SERVICE BULLETIN ML 0009

Date : 05 August, 1999
Game : Stop The Clock (Ticket)
Subject : Static "Zapping" Problems

Photo 1

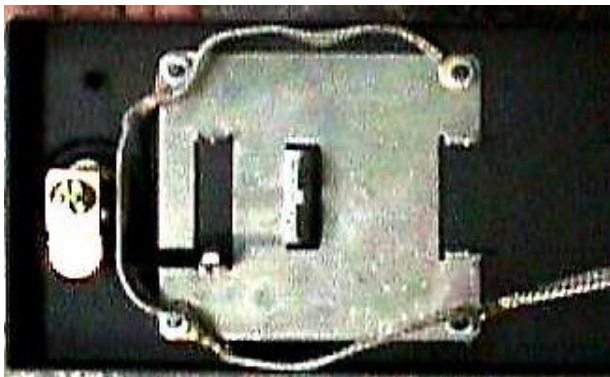
Problem : Static Zapping of Coin and Ticket door may cause erratic operation of game and ticket dispenser.

Solution : Fit Earth wire from Ticket Dispenser bracket directly to the Power Distribution Box. This can be made from 1mm² Wire or Brad of 1.5m in length. Attach one end to one or more of the Ticket Dispenser bracket Bolts (See Photo 1) and the other end on the Power Distribution Box earth binding post (See Photo 2). This part can be made available at your closest LAI Games Distributor.
